# Technical Memorandum

Date: 7 September 2017  
Project: 908157-03000

**Re: Southminster Church – 1040 Bank Street  
Residential Development – Parking Review**

Figure 2: Proposed On-Site and On-Street Parking – Net Gain of 7 Public On-Street Parking

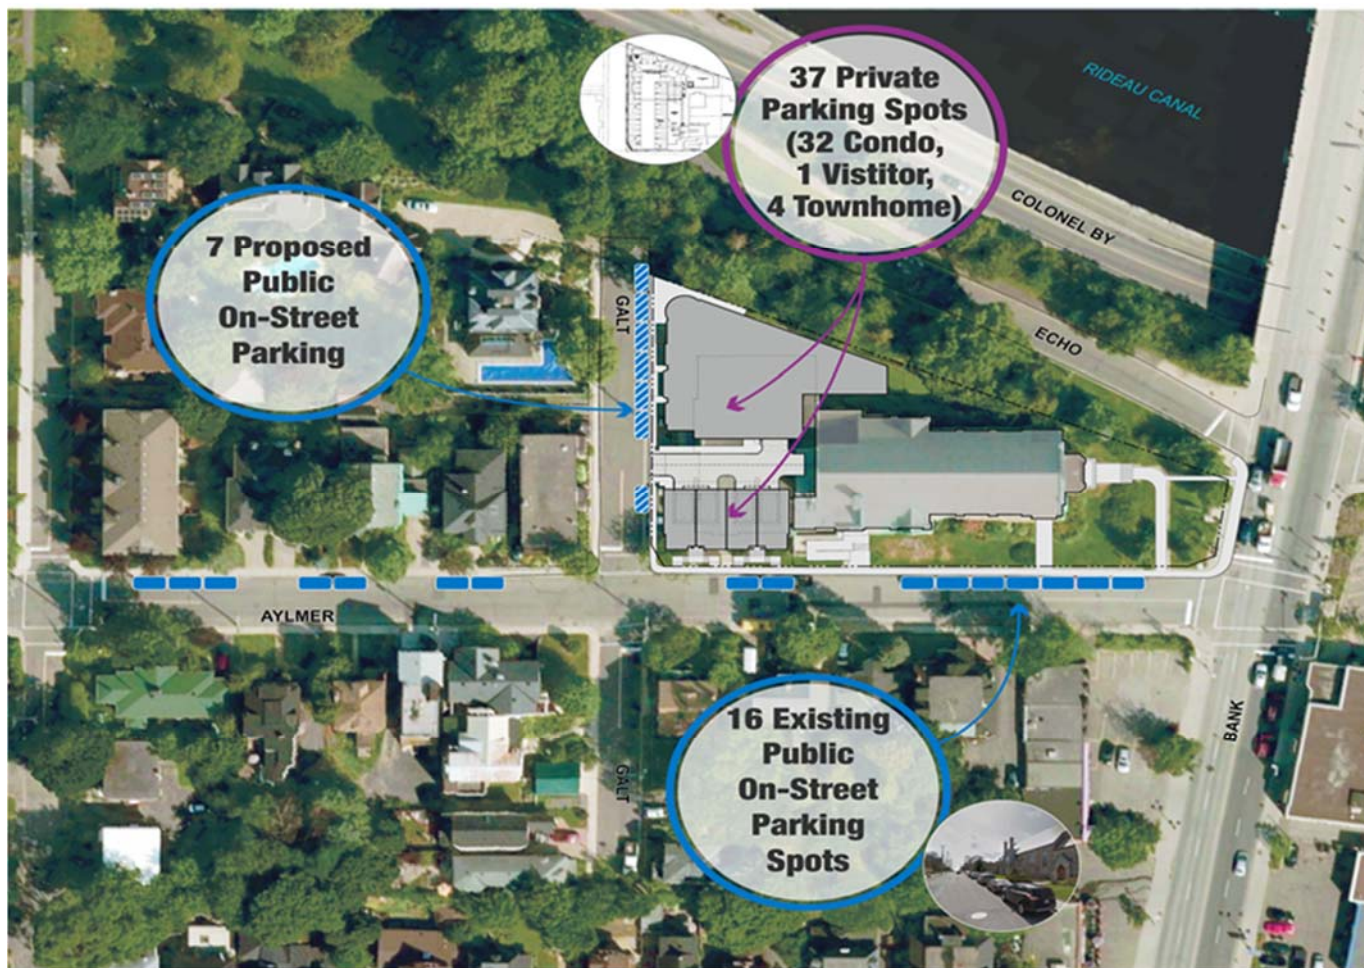
**Comment 13:** Please also provide a plan showing the proposed on-street parking configuration spaces along Galt Street and Aylmer Avenue.

**Response 13:** Please see Figure 2. A more detailed plan can be provided during the Site Plan Application stage and an RMA will be submitted if/when required. The estimated 7 parking spaces take into account the location of the proposed site driveway, the appropriate offset between parking and Aylmer Avenue, and the location of the MUP and fire hydrant at the north end of Galt Street. We are advised that the width required to implement on-street parking along a City roadway is 6 m of asphalt (minimum), which is currently provided along Galt Street.
